ICC A117.1 Comments on 1st Draft

Proposal list to the 2017 A117.1 for the 2023 edition – 8-31-2023 Chapter 1 to 5

Proposal list to the 2017 A117.1 for the 2023 edition – first draft comments

**FIGURE 506.10.2
TOP HANDRAIL EXTENSION AT STAIRS**

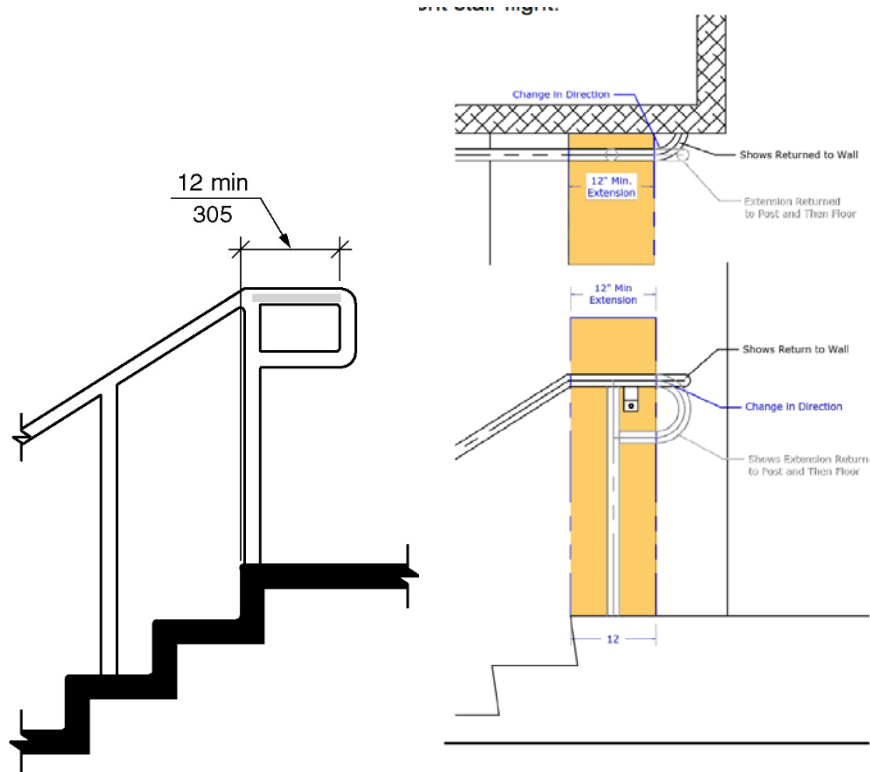
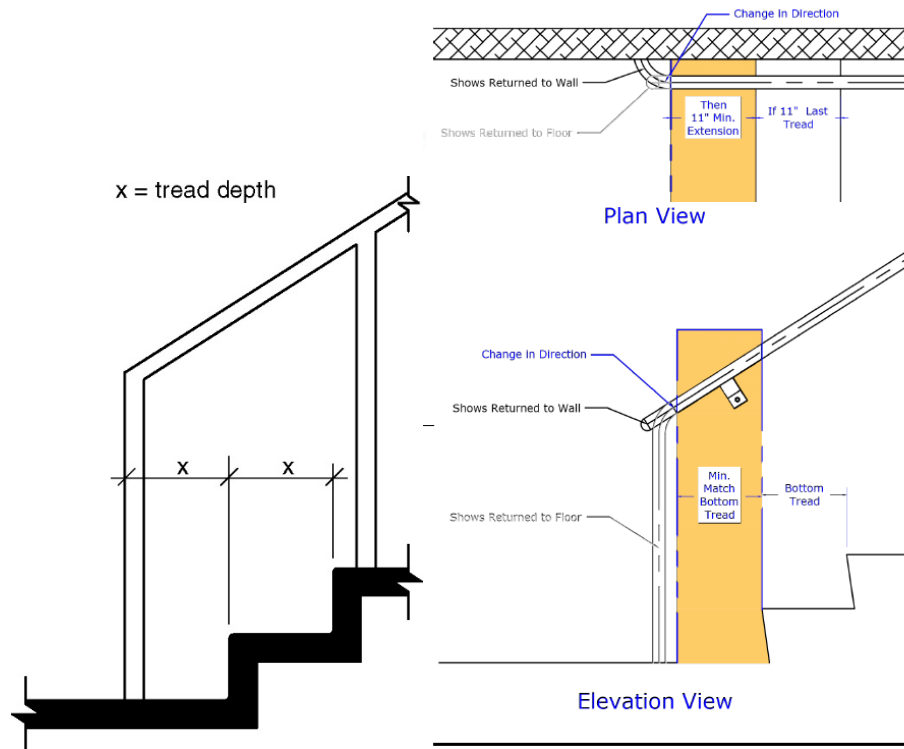
(Note: Replace existing figure.)

**FIGURE 304.3.2.1.1
T-SHAPED TURNING SPACE
NEW BUILDINGS - OVERLAP**

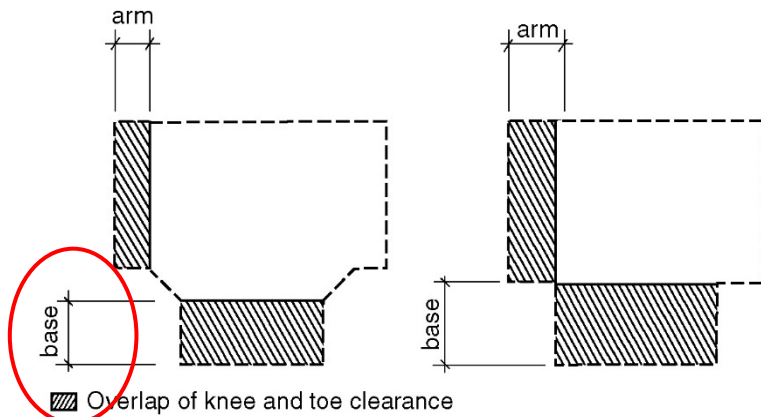
REASON: The purpose of this proposal is to coordinate the overlap allowances for turning spaces. The A117.1 decided not to change the knee and toe clearances between the 2009 and 2017 edition. The turning spaces have increased in size and substantially limited the overlap at the same time. Since the circle and T-turn are to turn 180 degrees, they should be consistent – while now there are substantial differences in all 4 options. With the larger turning space, these proposals will still be a reduction on the total percentage of the turning space permitted under the sink, counter or drinking fountain. With the current text people just play games with the options to get the best for that design – thus making it much harder to verify compliance. Below are proportional comparisons of the existing and new construction requirements.

**FIGURE 307.2
LIMITS OF PROTRUDING OBJECTS**

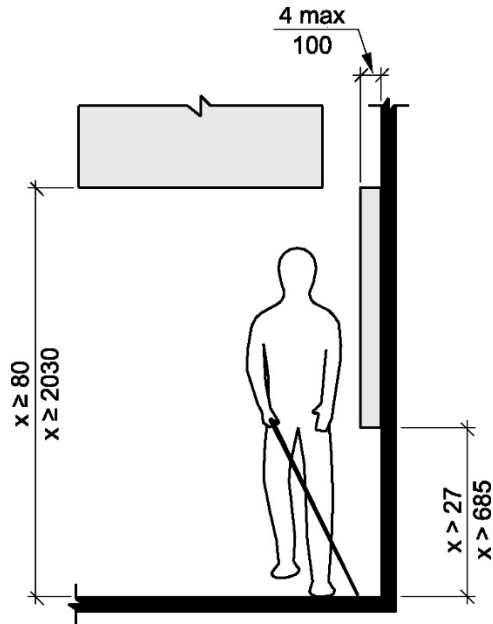
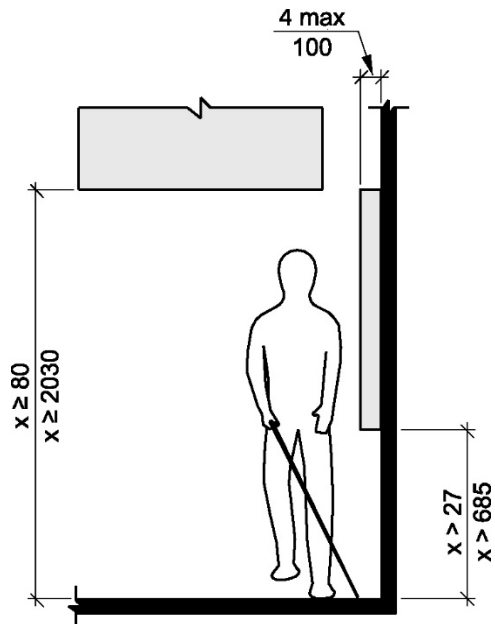
REASON: A typo and grammatical error in the original proposal were corrected and language added to clarify that this exception does not allow fixtures, countertops and equipment to be hazardous to someone walking in parallel direction. The last sentence clarifies where the leading edge should be measured.

Figure 307.3 (A)
POST-MOUNTED PROTRUDING OBJECTS

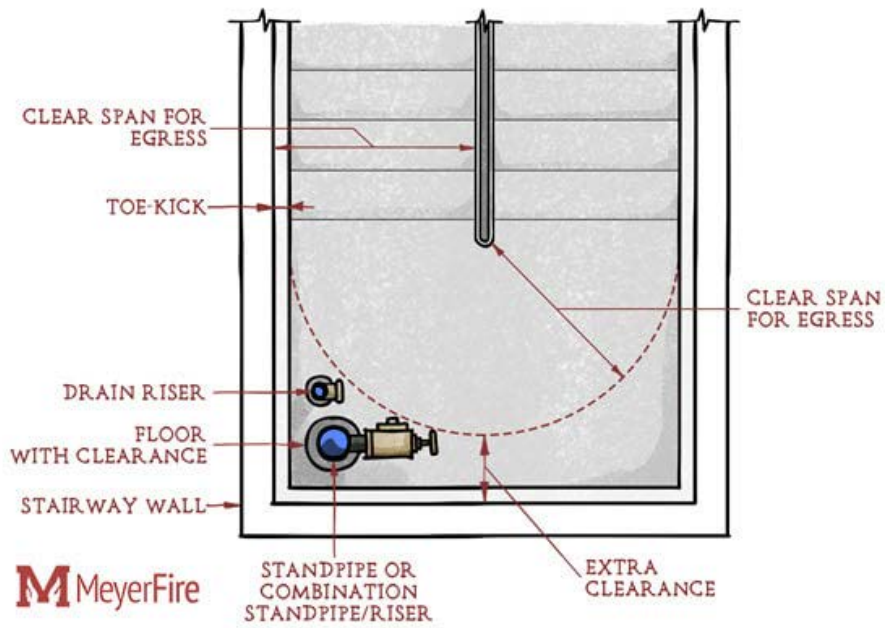
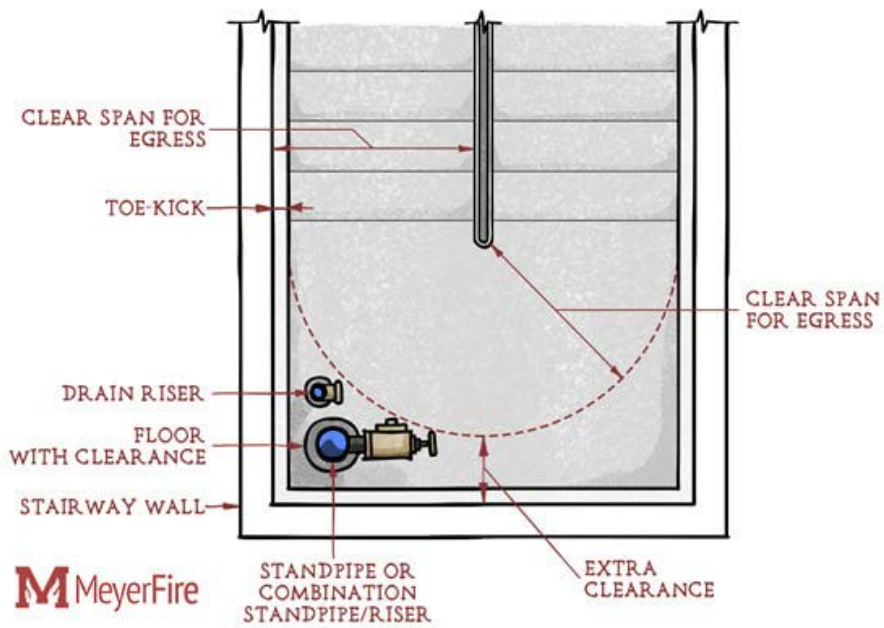
There is a current issue with standpipes where required in exit stairways. Fire department have to have access to connections, including substantial room for leverage to operate valves. Where designers have chosen cowl detection, access is limited. Where designers have chosen low bars for detection, some code officials have cited them for reducing the landing to below the required depth. **ADA allows for objects on posts to stick out 12” maximum.**

Reason: There is a current issue with standpipes where required in exit stairways. Fire department have to have access to connections, including substantial room for leverage to operate valves. Where designers have chosen cowl detection, access is limited. Where designers have chosen low bars for detection, some code officials have cited them for reducing the landing to below the required depth. **ADA allows for objects on posts to stick out 12" maximum.**

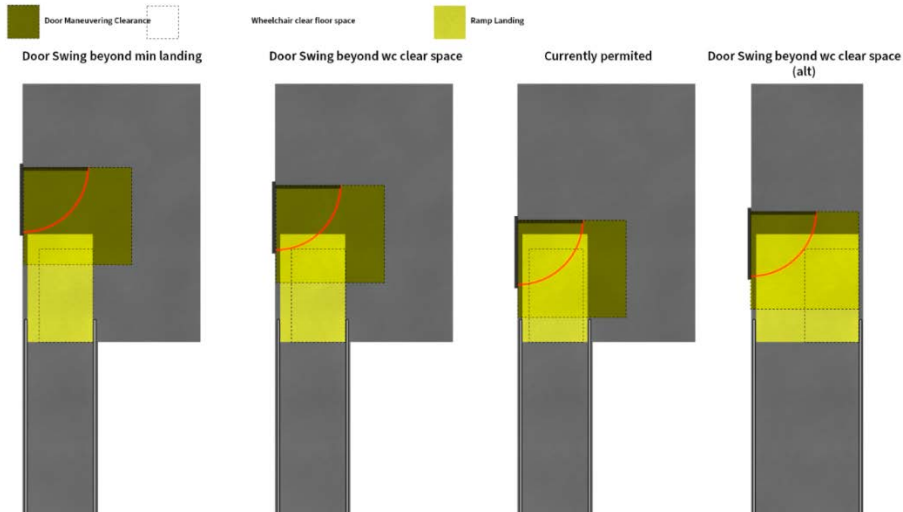
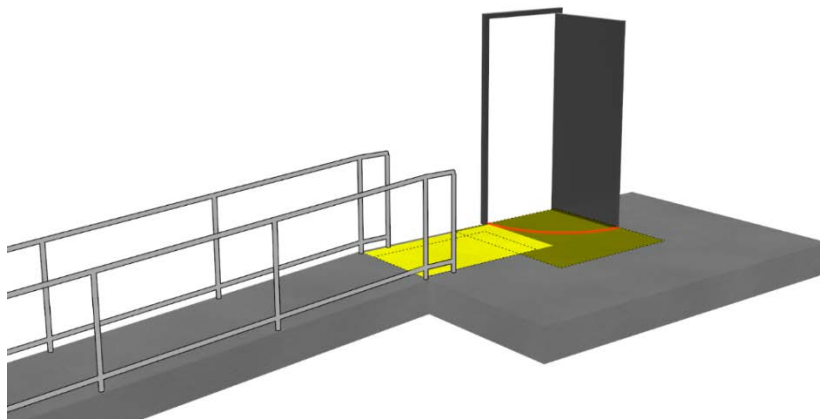
Proponent: Scott Windley, US Access Board

Replace with the following:

Report for 04-21– 2021		
<i>Committee decision: D</i>	<i>Committee Vote at Meeting: 16-5-1</i>	<i>Committee Vote on Ballot:37-3-1</i>
REPORT OF HEARING:		
Modification (if any):		
Committee Reason: While this proposal is appropriate for minimum size ramps and landings, there were a couple of concerns raised that need additional clarification. The committee agrees with the figures in the A117.1 commentary for Section 405.7.5 that illustrated the concerns for persons moving up a ramp to a landing with a door. However, if a ramp is very large, such as in a sports stadium, the doors swinging over the required ramp landing would most likely not be a conflict. If a ramp is for means of egress only, the door could swing over a ramp landing in the direction of travel.

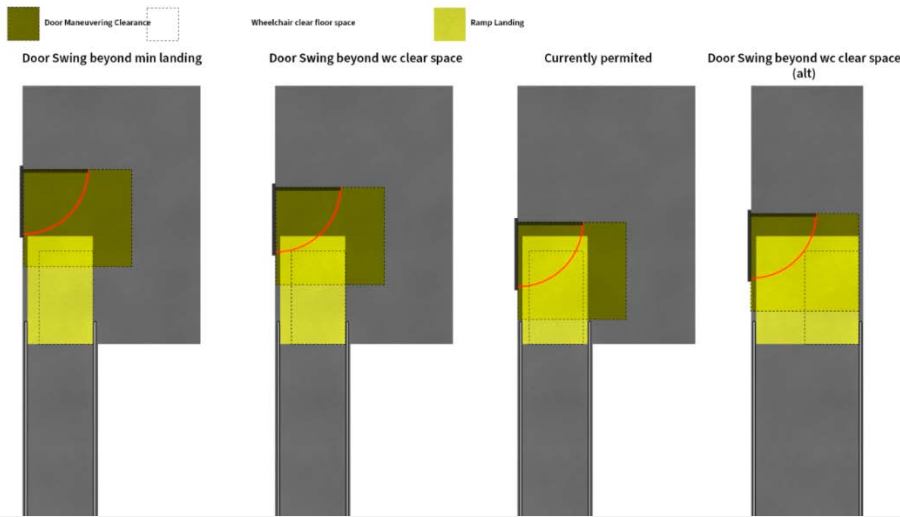
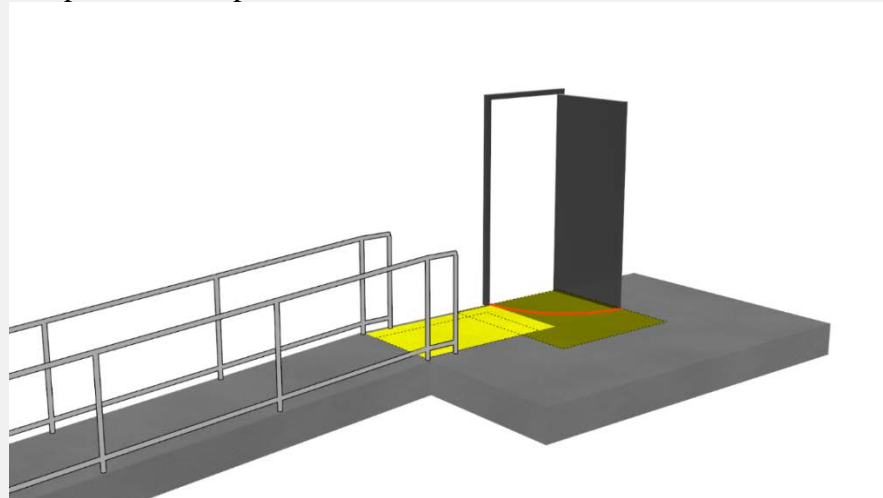
Desired Action: Negative with Comment

FIGURE 406.2(A)
PERPENDICULAR CURB RAMP

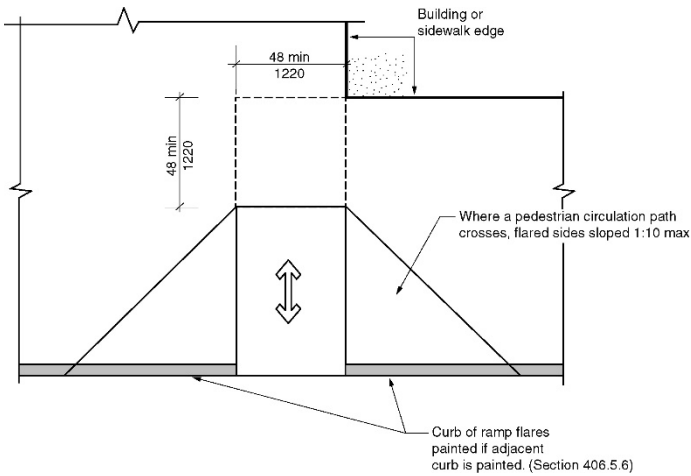
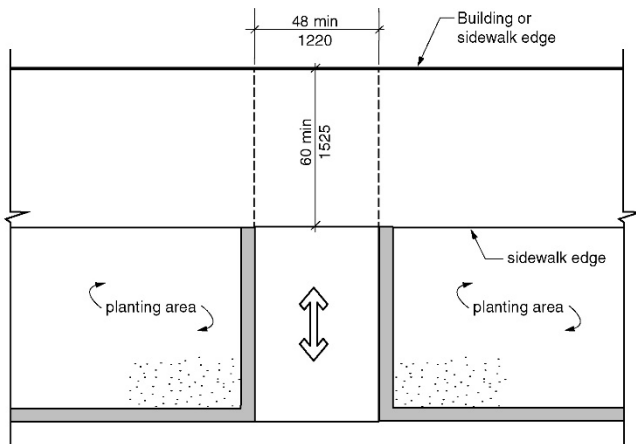
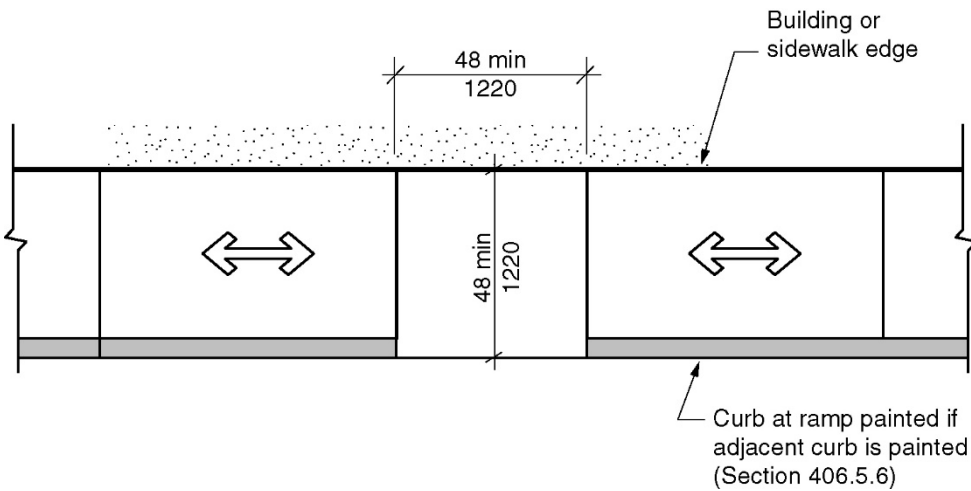
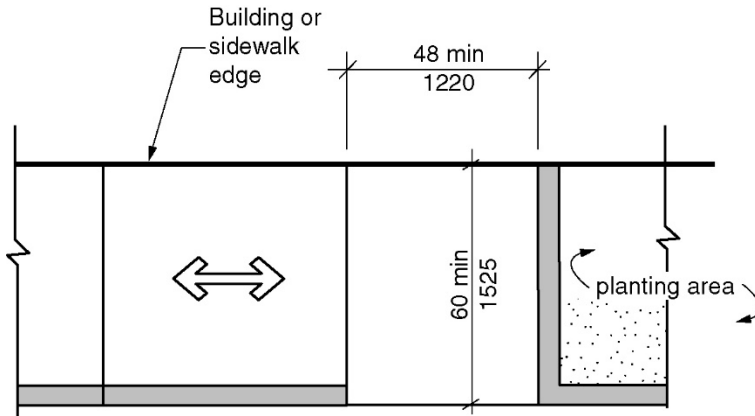
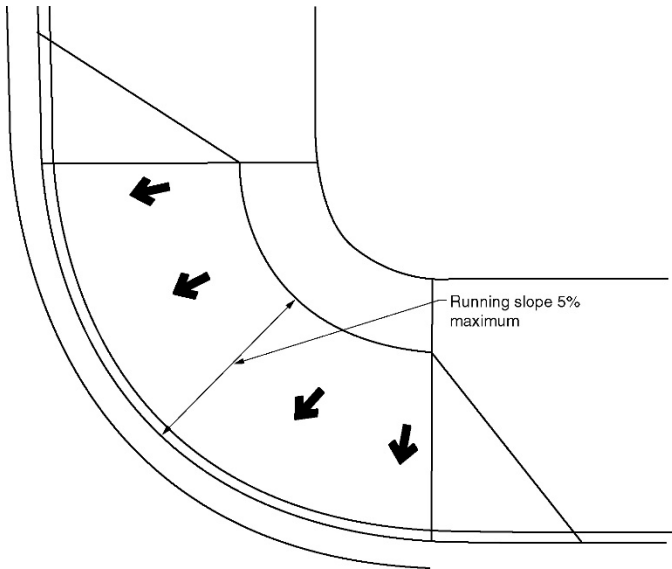
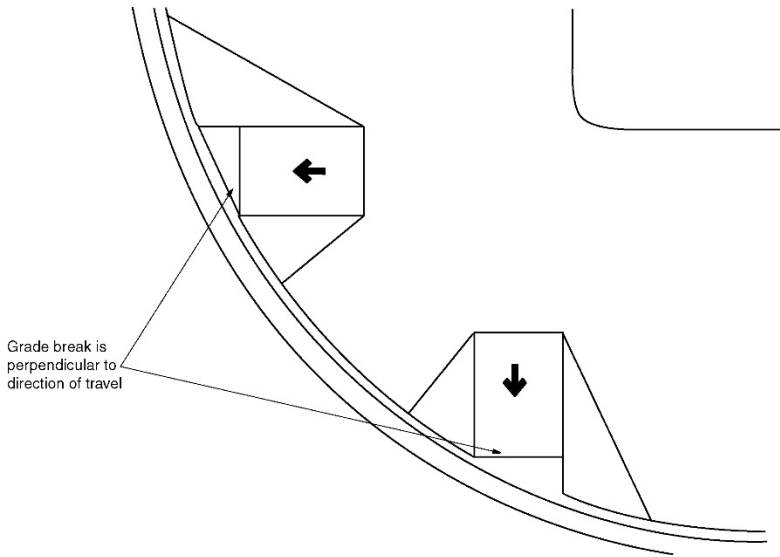
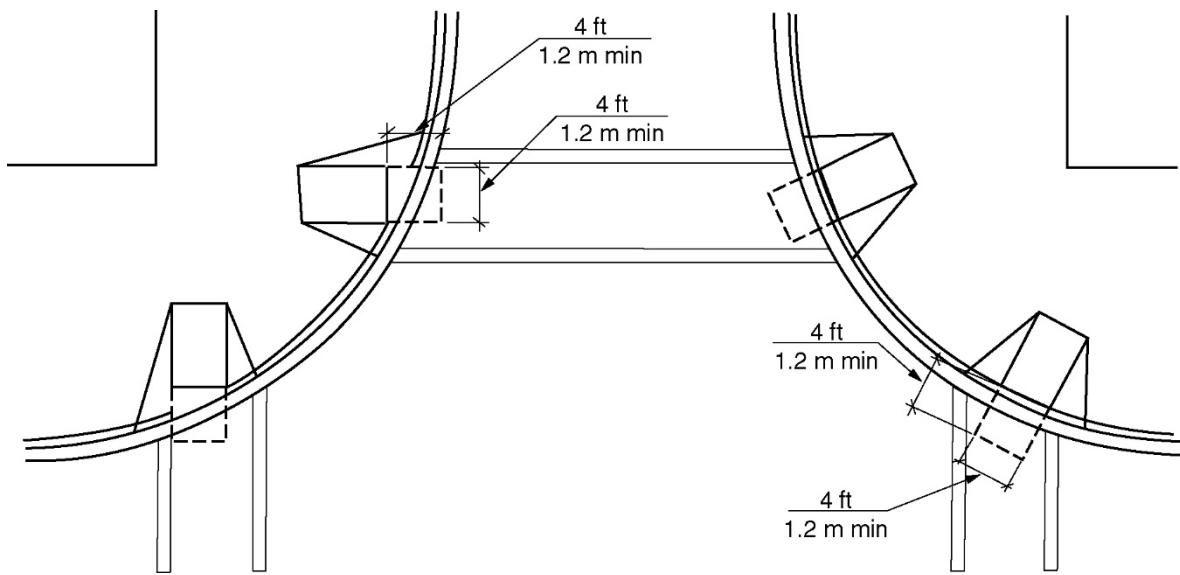
Note: These figures should all show detectable warnings.

REASON: Curb ramps are not complete without detectable warnings. While there is a section showing detectable warnings on curb ramps in some detail, they should not be omitted here. It implies that they are not required. Wherever curb ramps are depicted, unless they are not required to have detectable warnings, as in Figure 502.9.1, the detectable warning should be included. Figure 502.9.1.2 correctly includes the detectable warning, even though it is in Section 502 Parking Spaces.

Committee Reason: The first modification was approved because the committee felt that it was important to clarify that detectable warnings were only required in limited situations, thus the addition of the note in each drawing. The 2nd modification was approved to remove the original proposal’s suggestion to show the detectable warning on each curb cut. The committee felt that many people just looked at the pictures rather than the text, so showing the detectable warnings would be misleading. The final proposal was approved because the committee felt the note would address the concern for where detectable warnings would be required and at the same time not seem to require detectable warnings at all locations – especially at locations where detectable warnings would provide misinformation – like at access aisles or into parking lots. PROWAG requires detectable warnings at street crossings.

Figure 503.1.4.3
VEHICLE CHARGING SPACE ACCESS AISLE

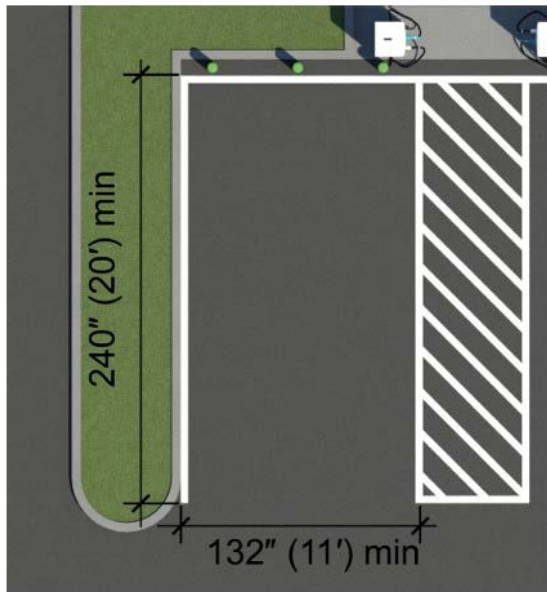
There was a suggestion to clarify which sizes for van spaces and the access aisle should be used since there are two choices in the A117.1 and the IBC requires the 132"/60" option.

Report for 05-08– 2021		
Committee decision: AS	Committee Vote at Meeting: 16-6-8	Committee Vote on Ballot: 40-0-1
REPORT OF HEARING:		
Modification (if any):		
Committee Reason: IBC scopes EV charging stations as a service. This would coordinate with A117.1 with the scoping terminology. There was a suggestion to clarify which sizes for van spaces and the access aisle should be used since there are two choices in the A117.1 and the IBC requires the 132"/60" option.		
BALLOT COMMENT- FIRST DRAFT:		
Proponent:		
Desired Action:		
Modification:		
Reason:		
Committee decision: AS/AM/D	Committee Vote at Meeting:	Committee Vote on Ballot:
REPORT OF HEARING – FIRST DRAFT		
Modification (if any):		
Committee Reason:		
BALLOT COMMENT- SECOND DRAFT:		
Proponent:		
Desired Action:		
Modification:		
Reason:		
Committee decision: AS/AM/D	Committee Vote at Meeting:	Committee Vote on Ballot:
FINAL ACTION:		
Modification (if any):
